# City of Detroit CITY PLANNING COMMISSION

**RE:** Request of Mariners' Church of Detroit for PC (Public Center) Special District Review of proposed exterior alterations to 170 East Jefferson Avenue – Mariners' Church of Detroit

(RECOMMEND APPROVAL WITH CONDITIONS)

# MASTER PLAN

principal in charge project manager project architect 07.28.2022

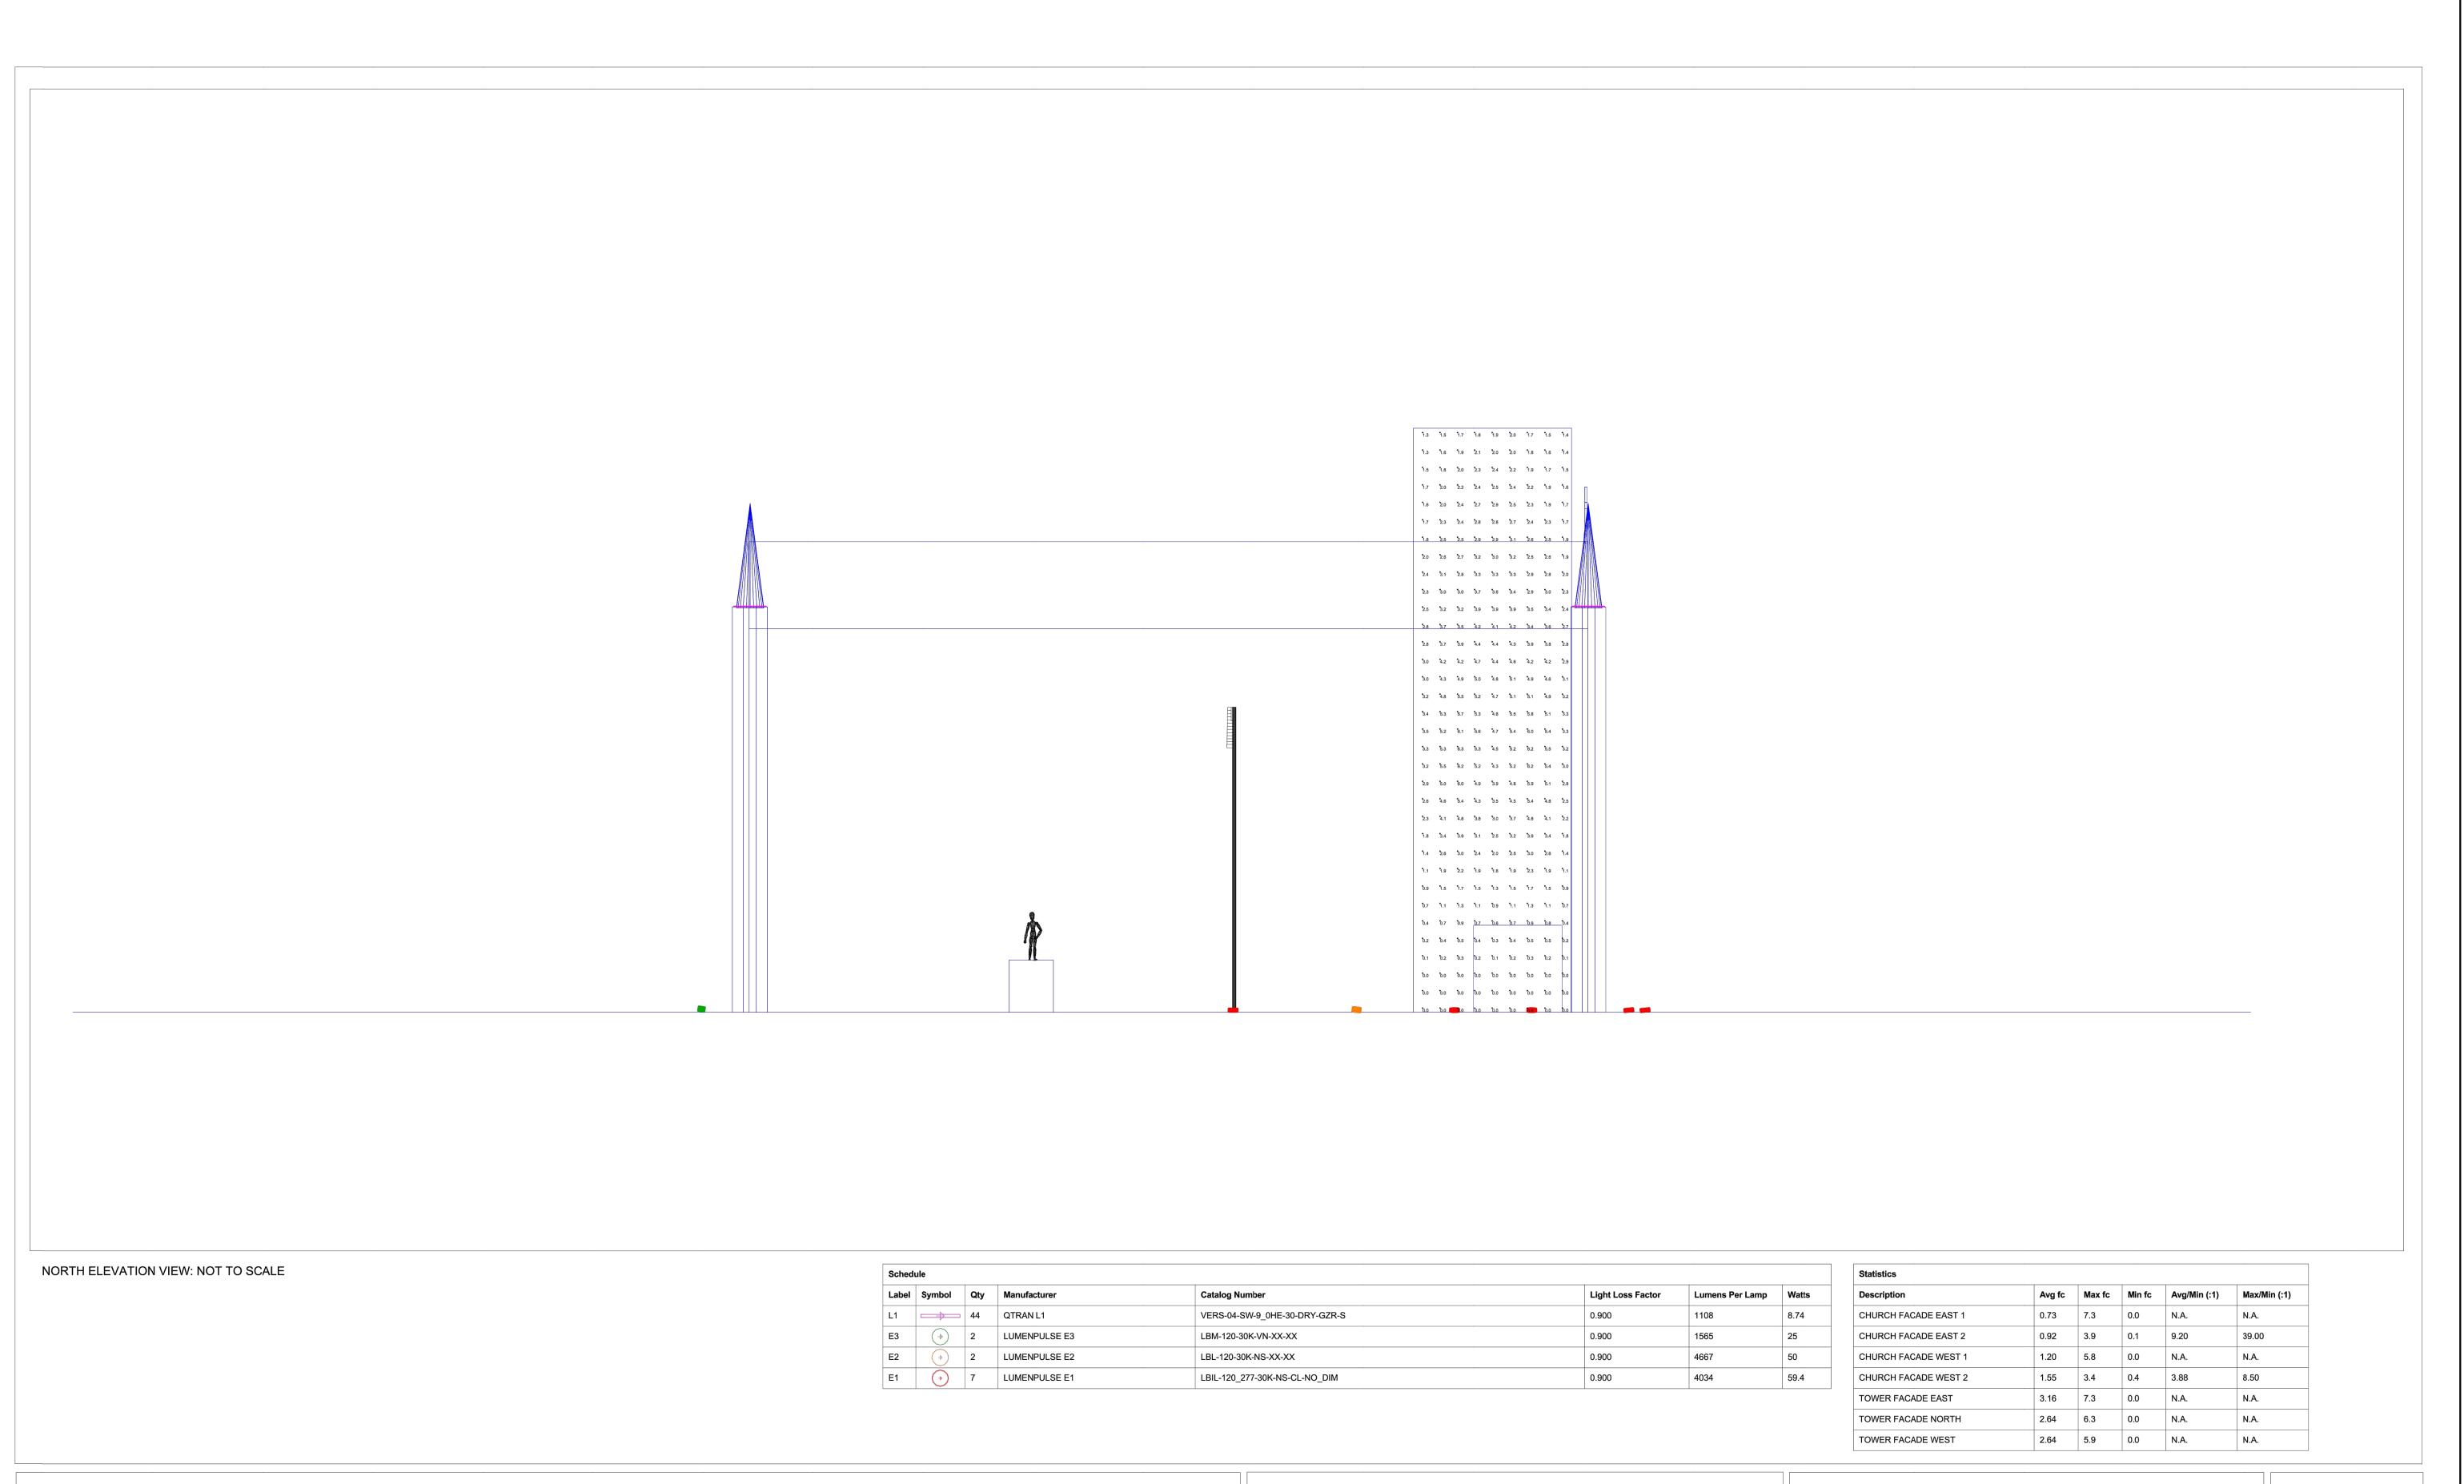
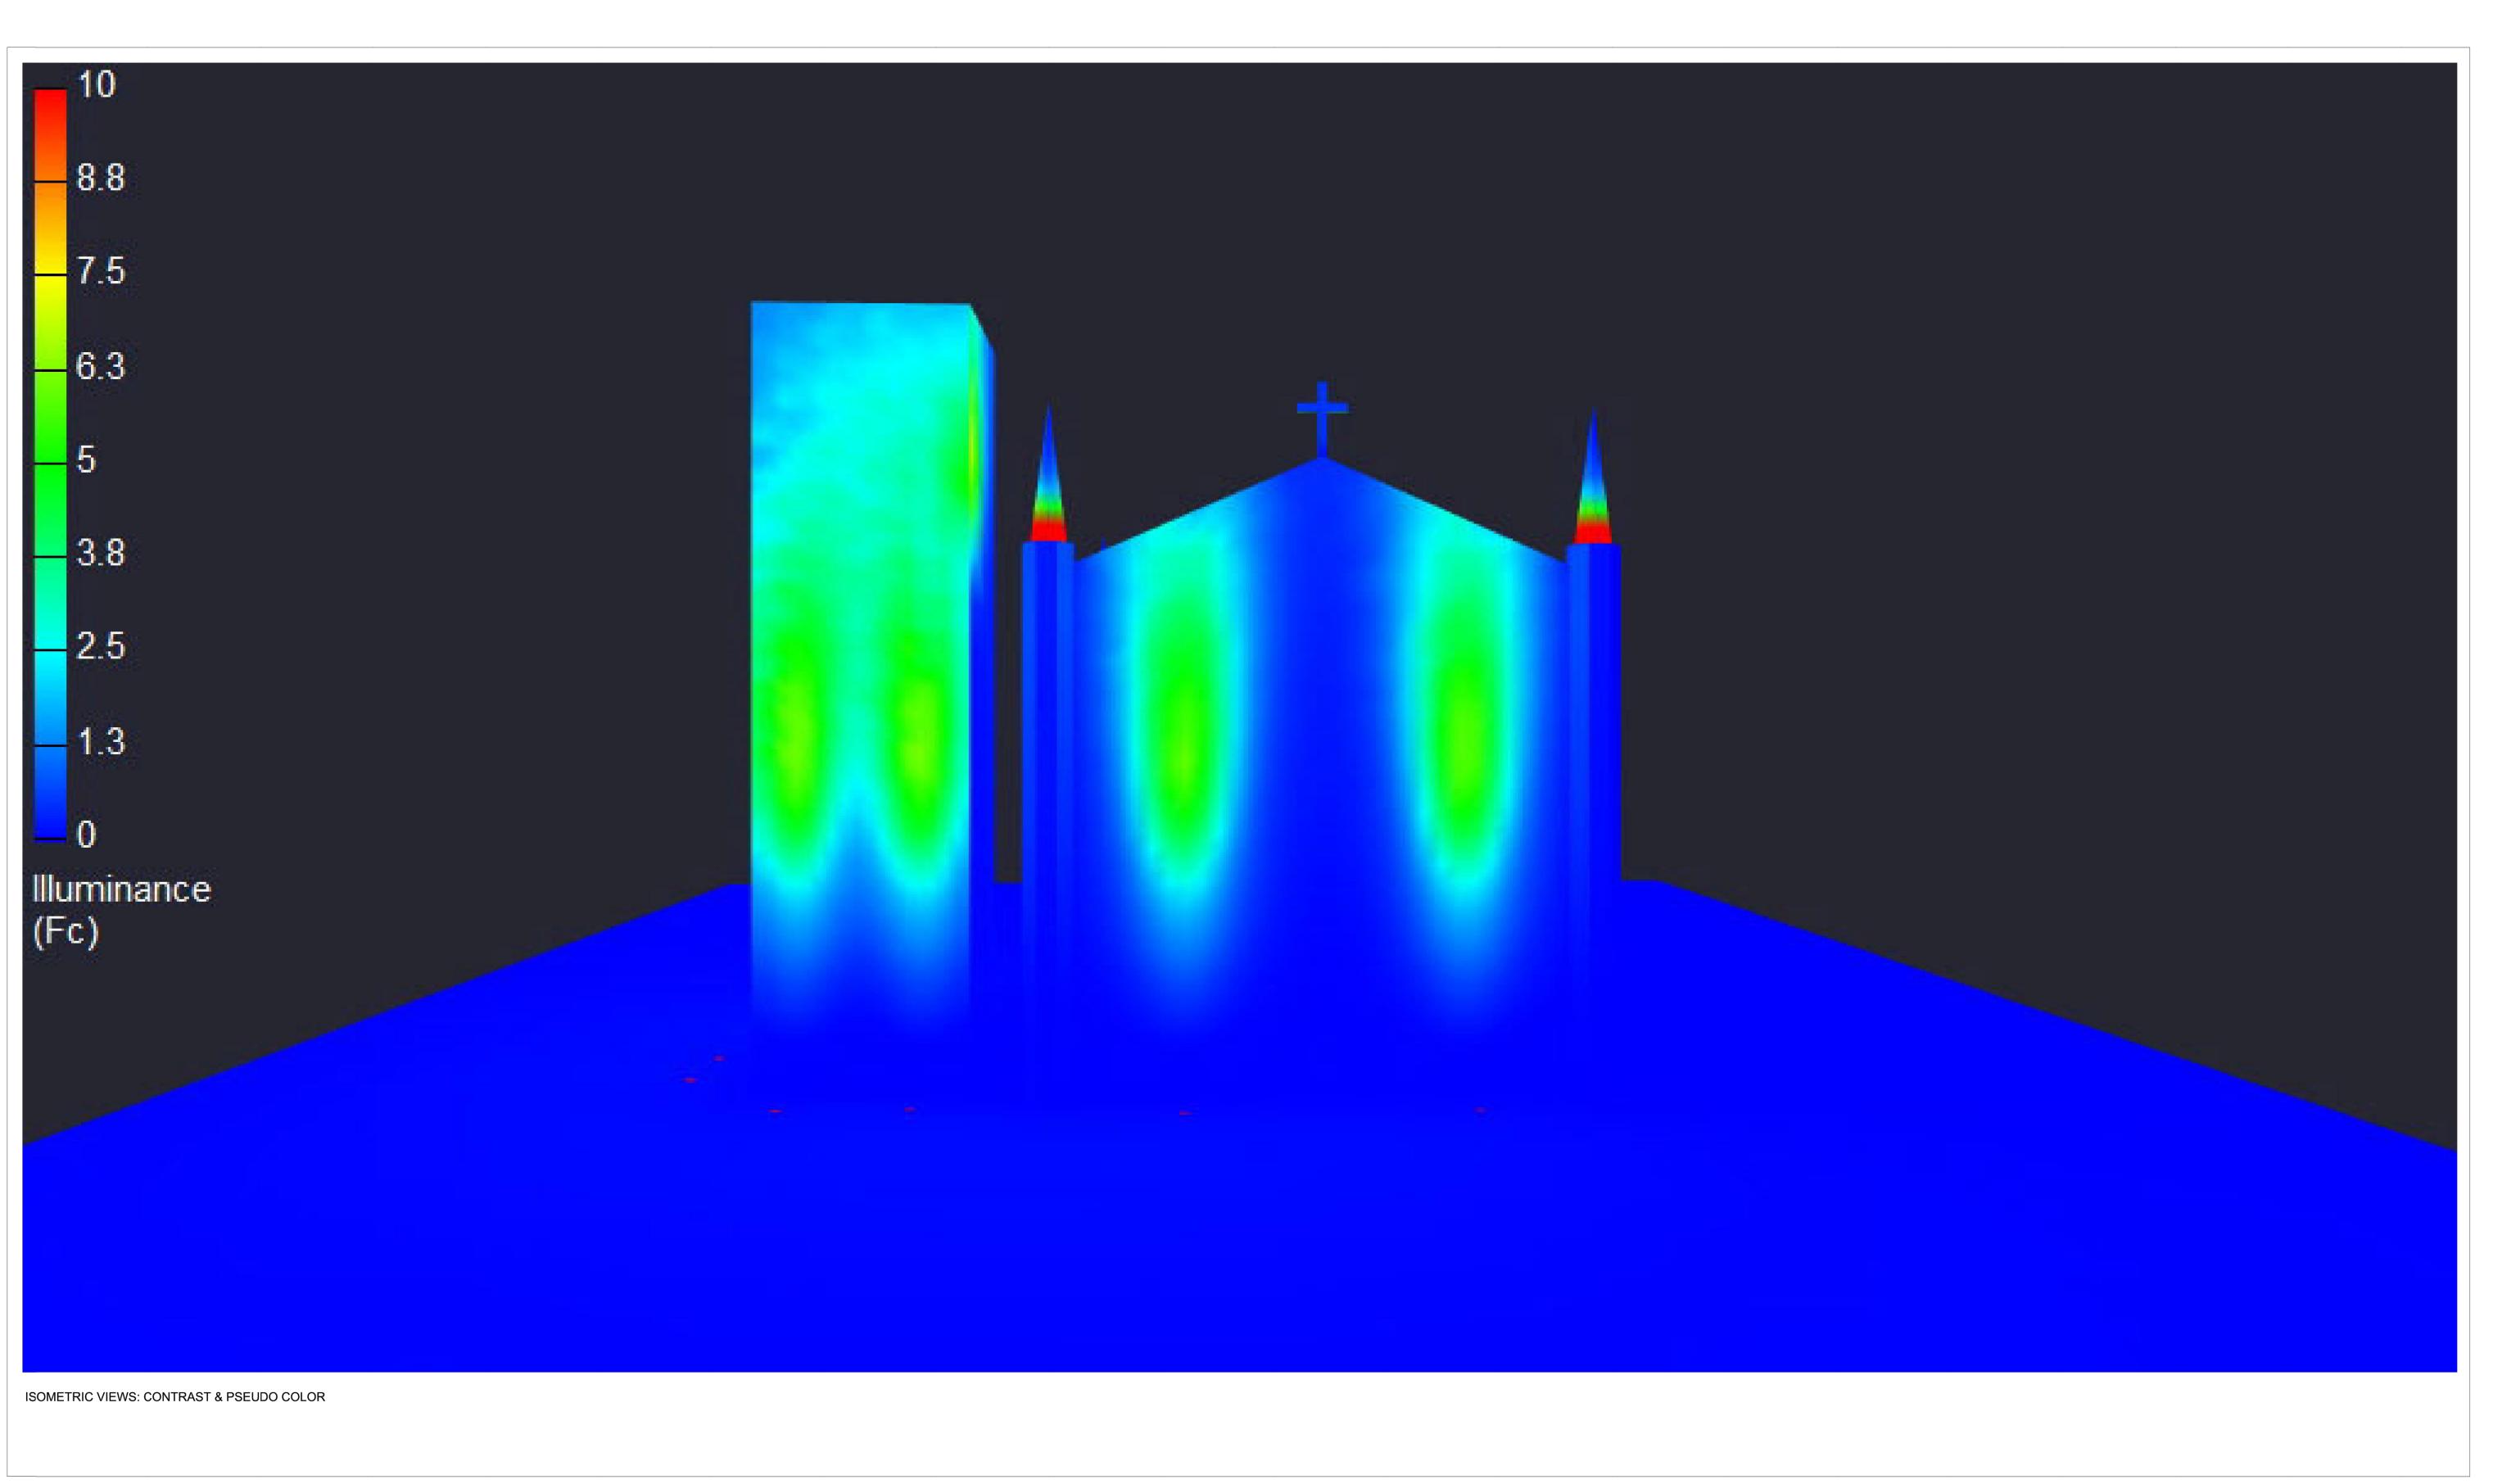
- a. Section 50-14-418 states that all reasonable measures shall be taken to ensure that off-site spillover of light and nightglow are minimized to the greatest extent possible.

- b. CPC staff finds that the revised Site Lighting plan dated July 28, 2022, would take reasonable measures to limit light spillover and nightglow as illuminance levels depicted on sheets A106, A108, and A110 indicate that the highest levels of illuminance would be focused on building facades, the tower, and pinnacles, and would not be focused off-site or directly into the sky. Additionally, there are numerous examples of buildings, especially churches, located within the Central Business District that have similar focused up-lighting provided.
